Kaixi Fashion Bangladesh Co Ltd

FS-SFB # 02,DEPZ(Old Zone),Ashulia,Savar,Dhaka-1349

15 November 2023

2. Observations

Observation-1: Discrepancy and missing information in as-built drawing (Main Building)

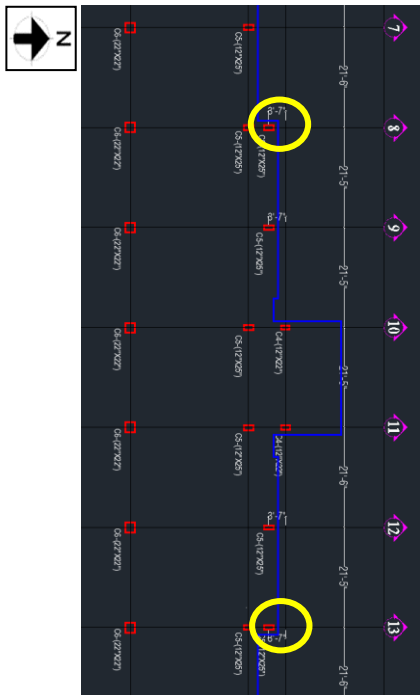
Description: L shape column is shown for each corner of the building, but arch shape column was found onsite.

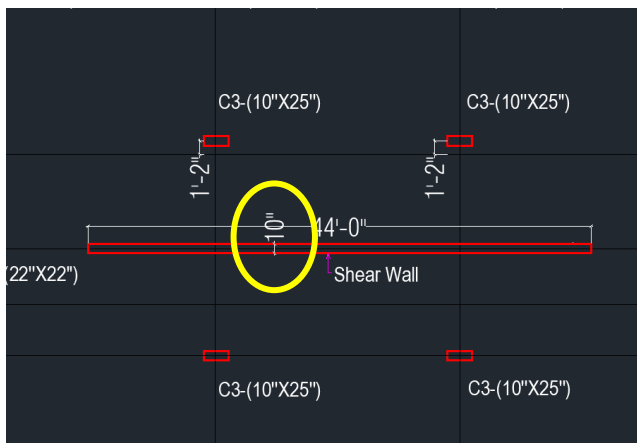
Description: Marked columns were shown as 625mmX300mm in drawing but found as 625mmX250mm.

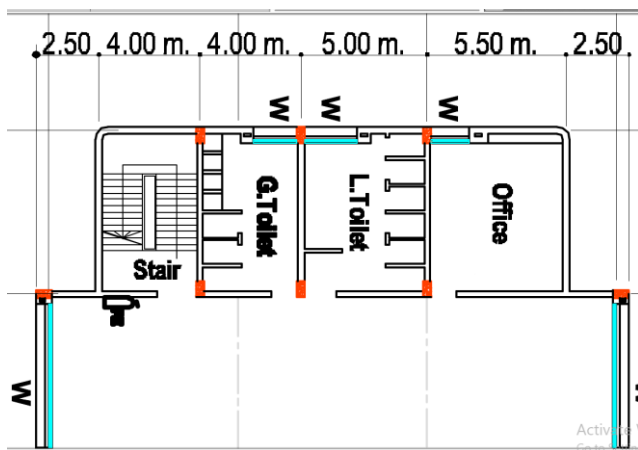
Description: Shear wall thickness was measured as 200 mm instead of 250 mm.
